Liddell Road Plans
Ref: 2014/7651/P and 2014/7649/P

I am writing to you as the director of a business employing approximately 16 people in Maygrove Road, immediately adjacent to the proposed Development referred to above.

**Proposed Section Through
75 Maygrove Road**

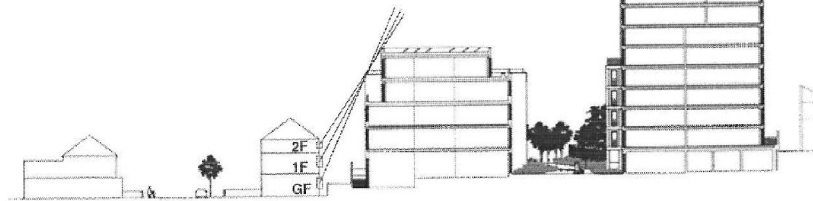
substantial changes proposed to existing ground level within extremely close proximity to the rear of our existing property - to be excavated with waste material removed from site

GF - Rights to light angle = 66°
1F - Rights to light angle = 61°
2F - Rights to light angle = 56°

My company has been at 75 Maygrove Road since this property was built in 2001/02 and feel that the loss of light would seriously diminish our use of the property. As can be noted within the above proposed section, extracted from the drawings issued as part of the application, the development represents an overbearing structure that will materially affect the internally space impact on its suitability. The rear windows currently provide adequate natural light levels for our required use, promoting a healthy working environment; however the proposals will create an insalubrious working environment impacting on the health and wellbeing of our longstanding workforce and the viability of our office space.

Additionally the level of excavation required within close proximity to our building is of concern. This will cause substantial disruption to our working environment due to the unacceptable increase in heavy trucks accessing the site to remove excess material. We would also question the environmental credentials of a scheme that requires such substantial ground works. We understand this has been proposed to minimise the height of the tower blocks. We would however suggest, that substantially reducing the height of these structures would be a more suitable solution as it would not burden the local infrastructure with the substantial level of trucks and heavy machinery required to complete these works.
